工程指示 / 要求簡箋 ENGINEER INSTRUCTIONS(E.I.)

工程指示編號:	EI- 4869C	修改版本:	C
	HK- 1528		
工程編號:	J 853	工程名稱:	大窩坪 (延坪道)
收件人:	生統	發件人:	Lai Sik Hung
工程項目:	T1及T7 幕牆單元背板生產 大貨 (修訂C:T1修改分格高度及避地台碼位)	日期:	05/09/2022

內容: 修訂C : T1修改分格高度及避地台碼位

名稱	背板拆圖	制圖	陳敏聰	2022.04.13	修改	新增	
材料	2mm 鋁板	復核	謝永林	2022.04.14	日期	2022.09.02	
顏色	UCT542049SC-3(淺灰)	批准	Daniel		圖號	DBP-14k

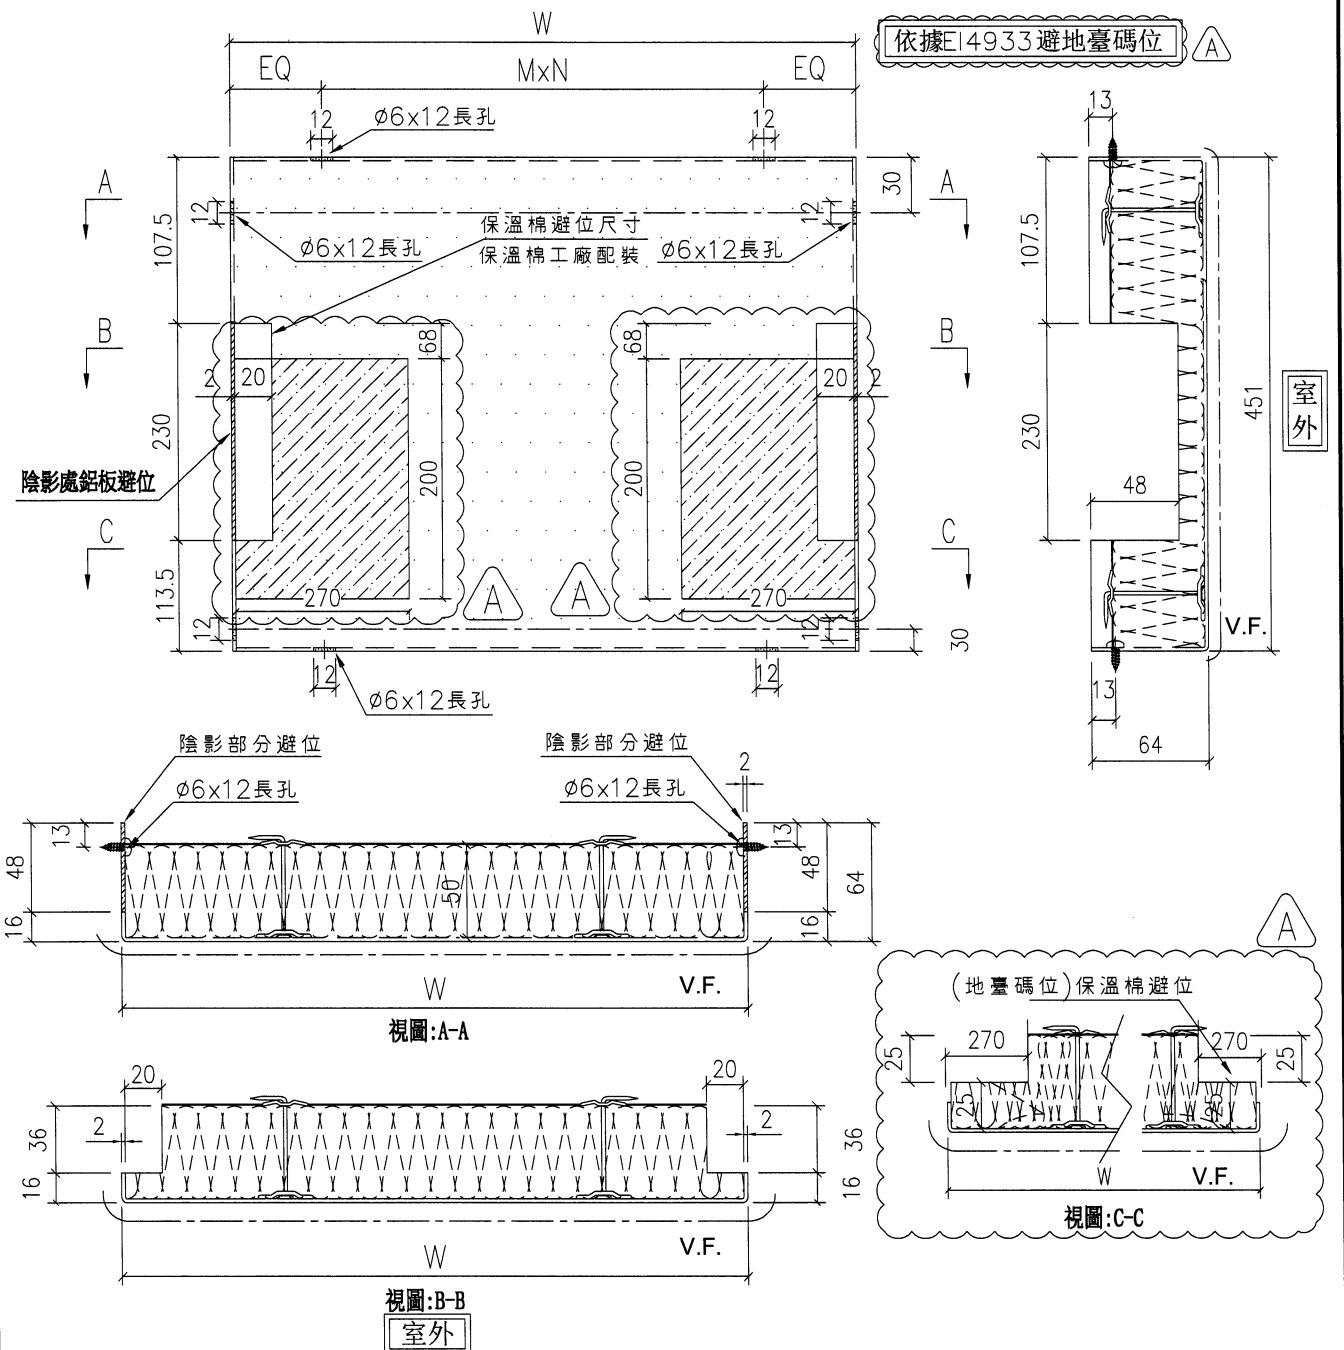
依據EI4949修改分格高度

序號	物料編號	W	數量	EQ	M	X	N	位置	分格尺寸	樓層	樓層數	每層數量	備註
1	DBP-14k	1011	1	55.5	300	x	3	J853-SD-CW-4102	1115	22/F	1	1	原340改585
2	DBP-110k	1536	1	143.0	250	x	5	J853-SD-CW-4103	1640	22/F	1	1	原340改585
3	DBP-112k	911	1	80.5	250	x	3	J853-SD-CW-4104	1015	22/F	1	1	原340改585
4	DBP-6k	496	2	98.0	300	x	1	J853-BD-CW-4101	600	23/F	1	2	原390改585
5	DBP-6k	496	2	98.0	300	x	1	J853-BD-CW-4101	600	23/F	1	2	原390改585
6	DBP-102k	2008.5	1	104.3	300	x	6	J853-BD-CW-4101	2112.5	23/F	1	1	原390改585
7	DBP-103k	2008.5	1	104.3	300	x	6	J853-BD-CW-4101	2112.5	23/F	1	1	原390改585
總數:			9

名稱	背板拆圖	制圖	陳敏聰	2022.04.13	修改	新增	
材料	2mm鋁板	復核	謝永林	2022.04.14	日期	2022.09.02	
顏色	UCT542049SC-3(淺灰)	批准	Daniel		圖號	DBP-06k(2)

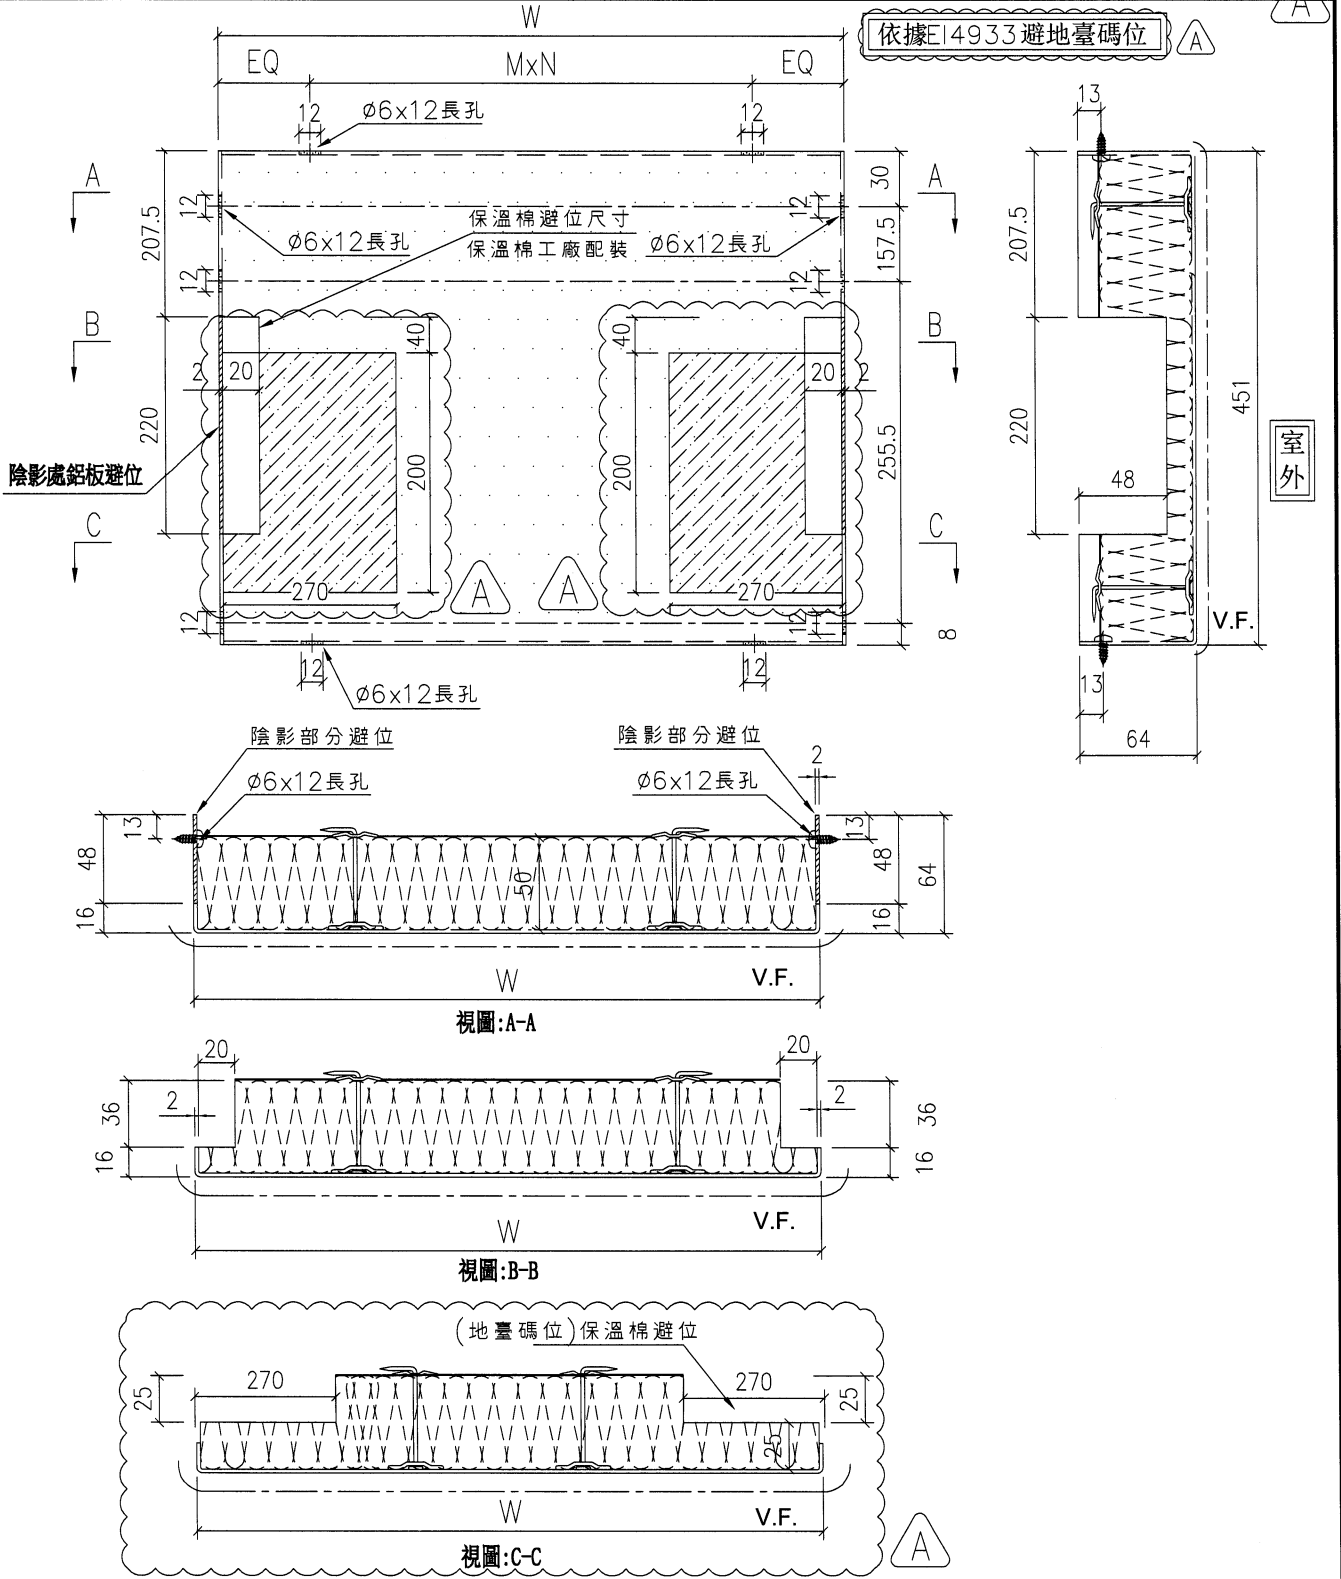
依據EI4949修改分格高度

序號	物料編號	W	數量	EQ	M	X	N	位置	分格尺寸	樓層	樓層數	每層數量	備註
1	DBP-6k(2)	496	1	98.0	300	x	1	J853-BD-CW-4101	600	22/F	1	1	原340改585
2	DBP-6k(2)	496	1	98.0	300	x	1	J853-BD-CW-4101	600	22/F	1	1	原340改585
3	DBP-101k	1458.5	1	129.3	300	x	4	J853-BD-CW-4101	1562.5	22/F	1	1	原340改585
4	DBP-104k	1458.5	1	129.3	300	x	4	J853-BD-CW-4101	1562.5	22/F	1	1	原340改585
總數:			4

名稱	背板拆圖	制圖	陳敏聰	2022.04.13	修改	新增	
材料	2mm鋁板	復核	謝永林	2022.04.14	日期	2022.09.02	
顏色	UCT542049SC-3(淺灰)	批准	Daniel		圖號	DBP-06c

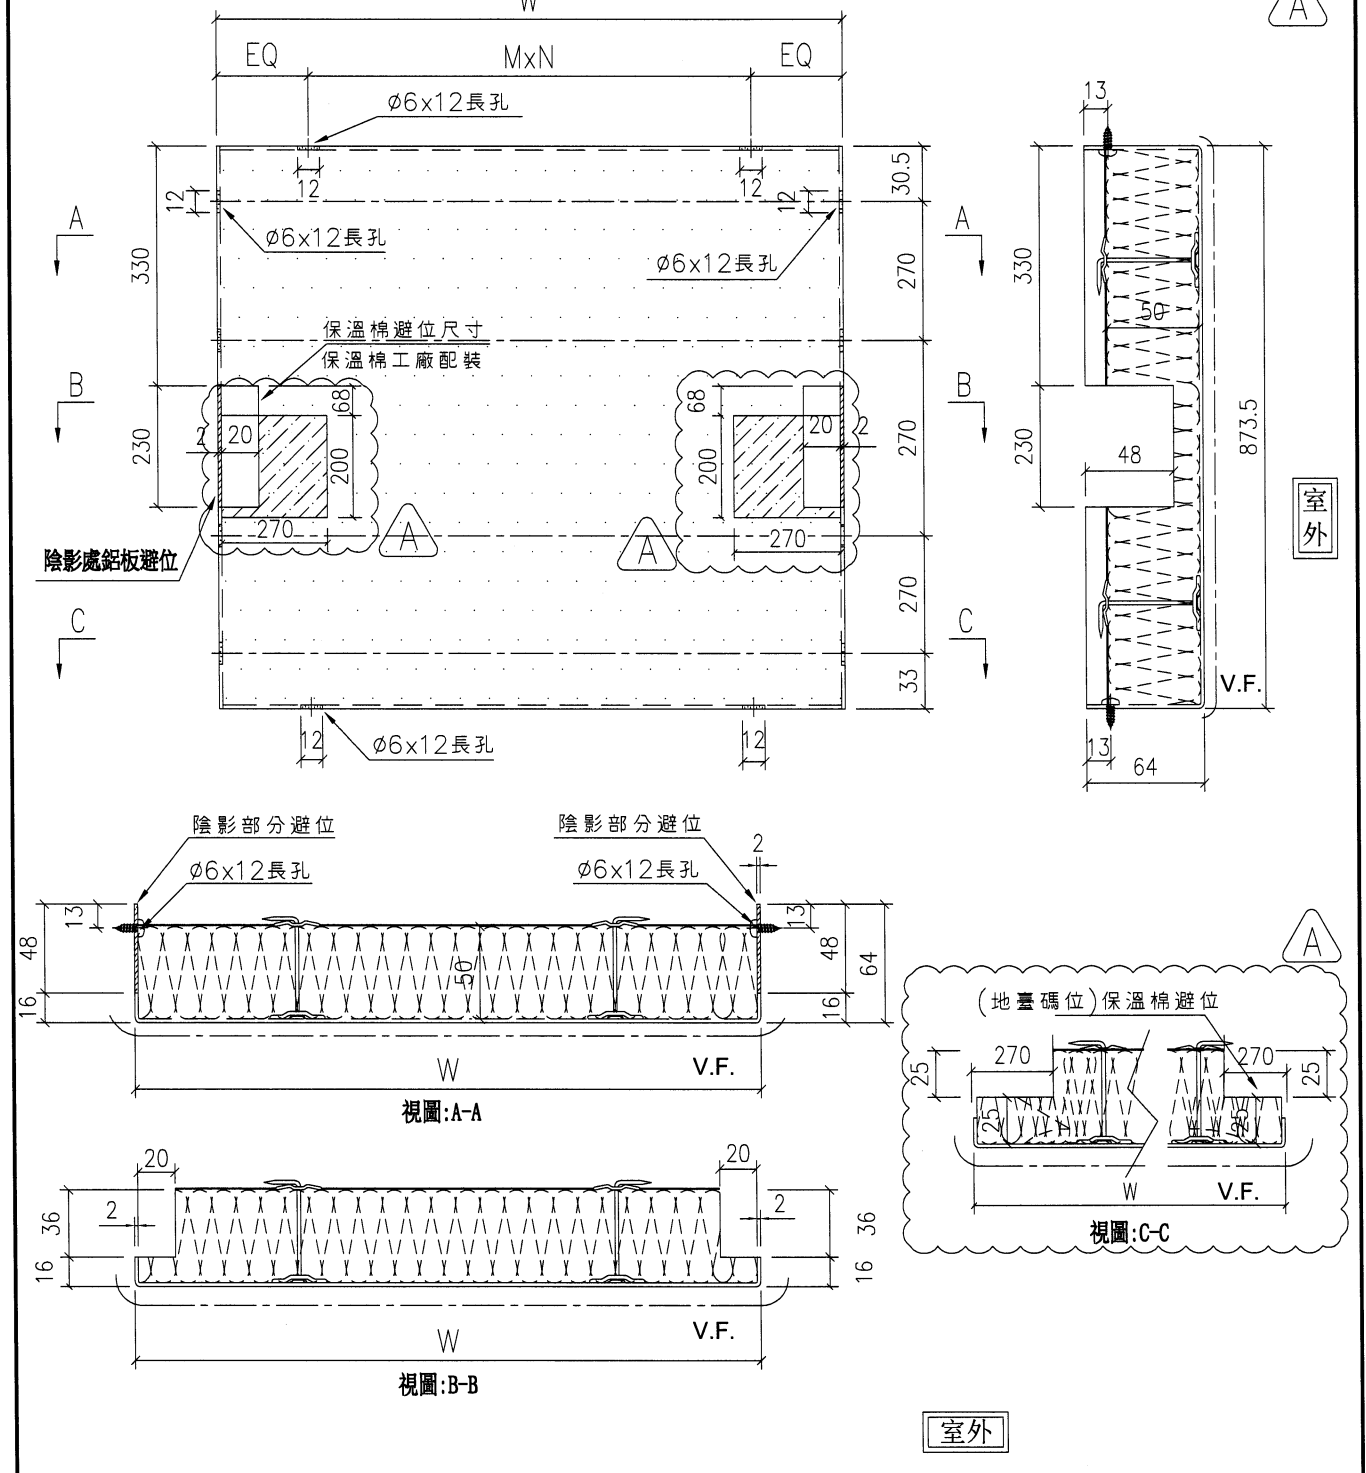
依據EI4933避地臺碼位

依據EI4949修改分格高度

序號	物料編號	W	數量	EQ	M	X	N	位置	分格尺寸	樓層	樓層數	每層數量	備註
1	DBP-6c	496	2	98.0	300	x	1	J853-BD-CW-4101	600	22/F	1	2	原957.5改1007.5
2	DBP-6c	496	2	98.0	300	x	1	J853-BD-CW-4101	600	22/F	1	2	原957.5改1007.5
3	DBP-102c	2008.5	1	104.3	300	x	6	J853-BD-CW-4101	2112.5	22/F	1	1	原957.5改1007.5
4	DBP-103c	2008.5	1	104.3	300	x	6	J853-BD-CW-4101	2112.5	22/F	1	1	原957.5改1007.5
總數:			6

名稱	背板拆圖	制圖	陳敏聰	2022.04.13	修改	A	
材料	2mm鋁板	復核	謝永林	2022.04.14	日期	2022.09.02	
顏色	UCT542049SC-3(淺灰)	批准	Daniel		圖號	DBP-06

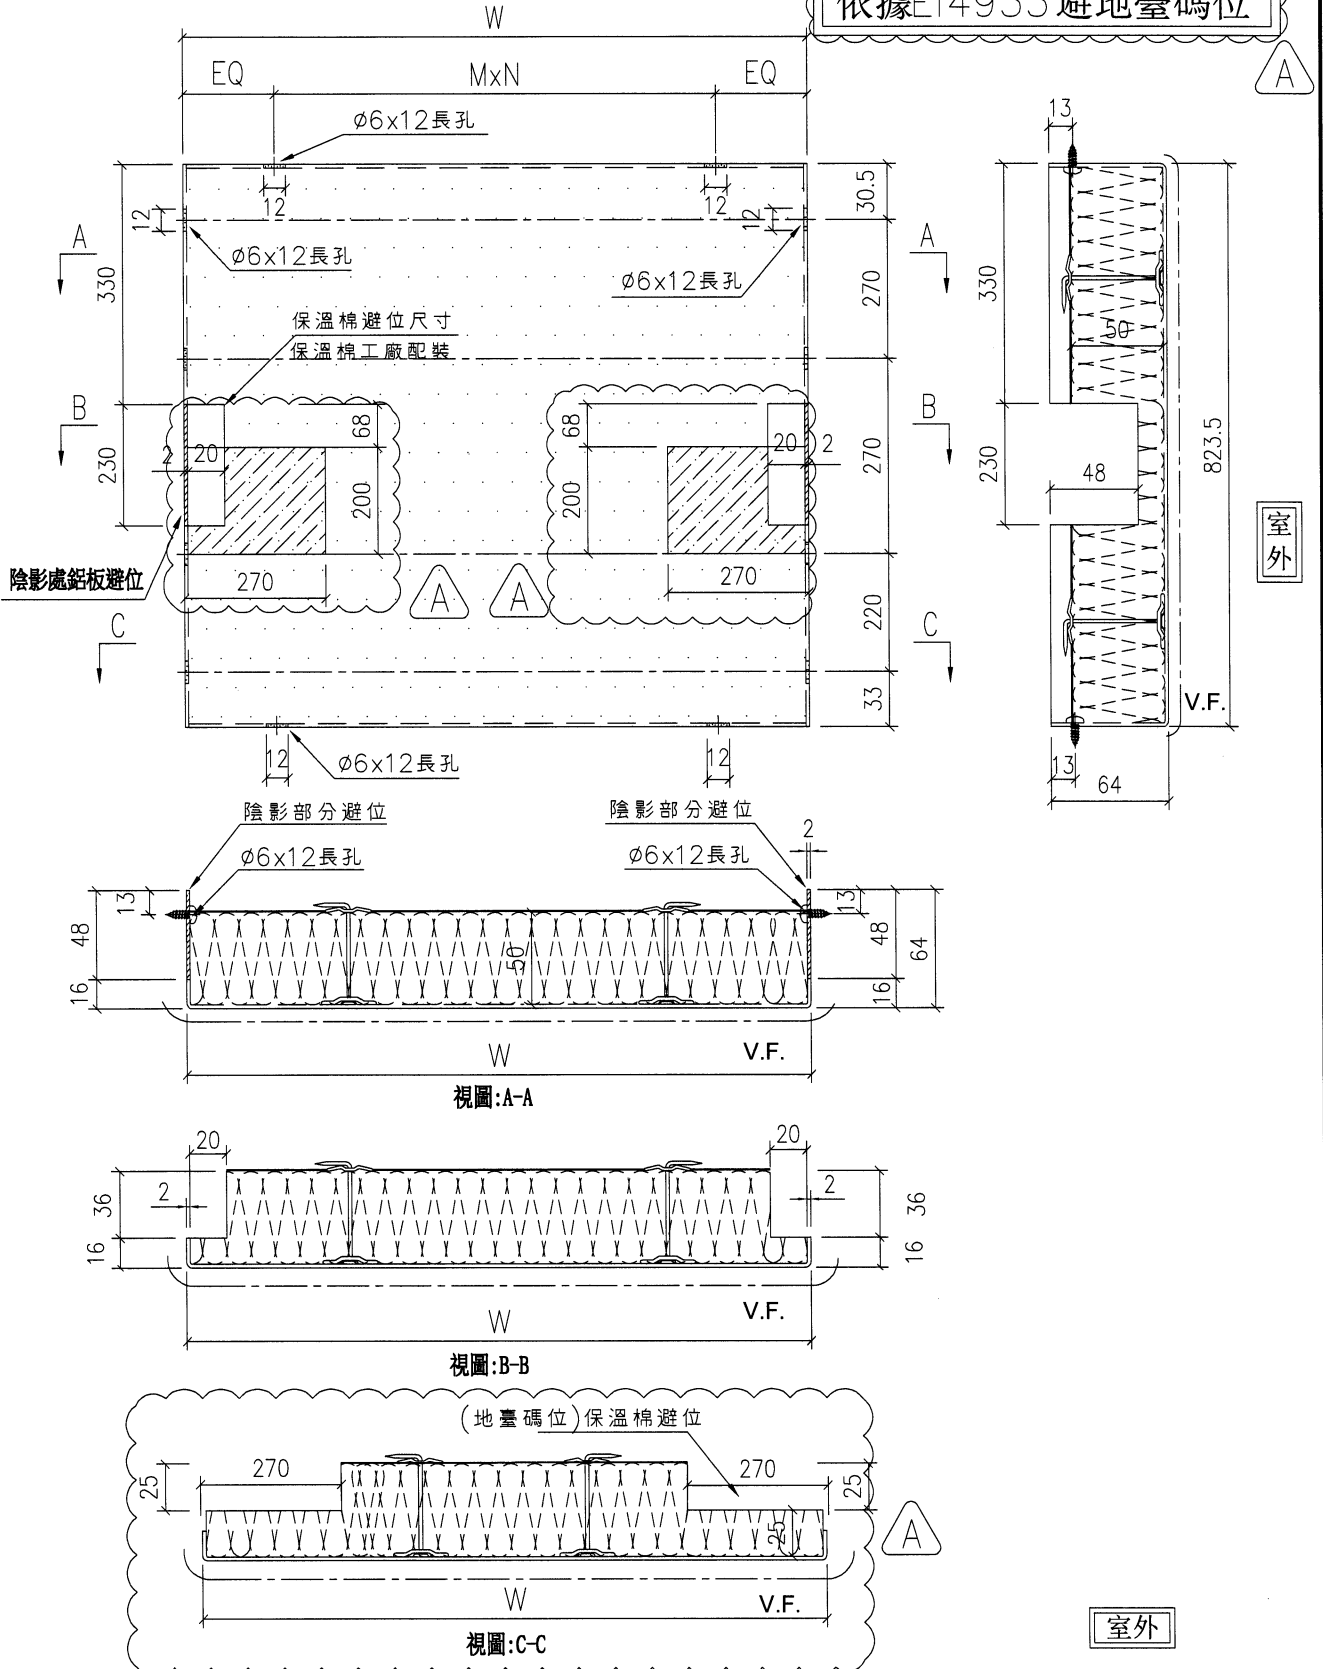
依據E14933避地臺碼位

名稱	背板拆圖	制圖	陳敏聰	2022.04.13	修改	A	
材料	2mm鋁板	復核	謝永林	2022.04.14	日期	22.09.02	
顏色	UCT542049SC-3(淺灰)	批准	Daniel		圖號	DBP-12d

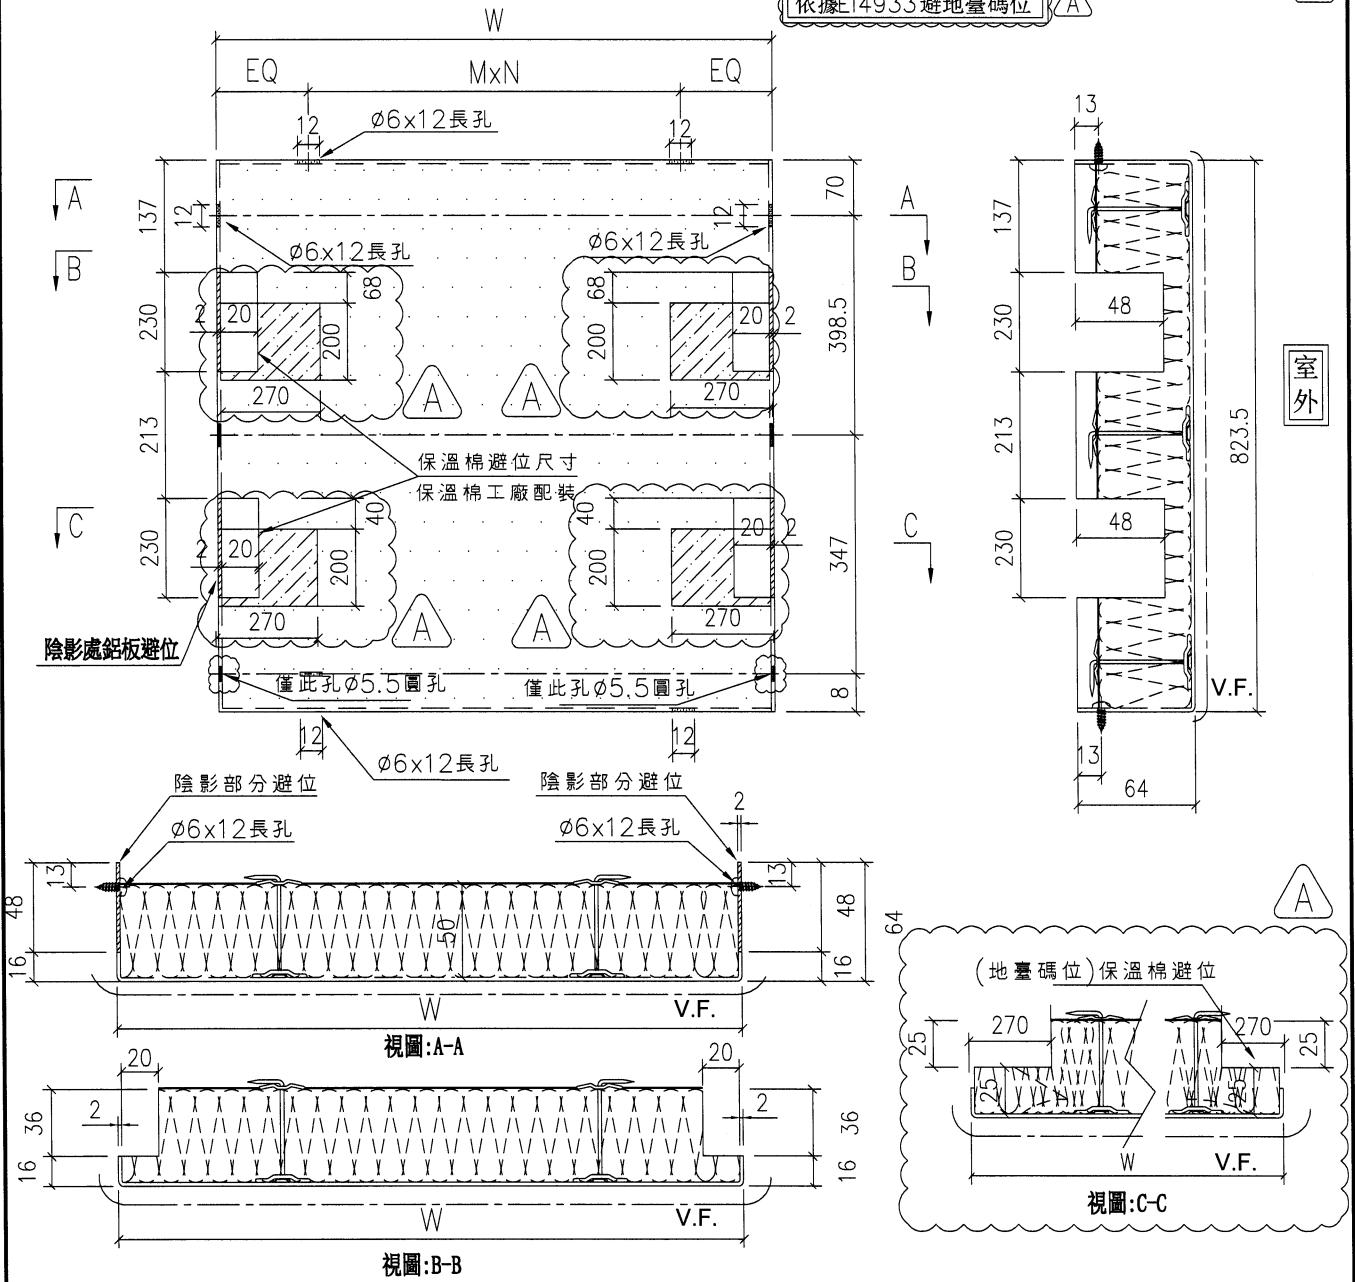
注：DBP-103d如果已加工就重做

依據E14439A修改鋁板掛碼避位

依據E14949修改分格高度

依據E14933避地臺碼位
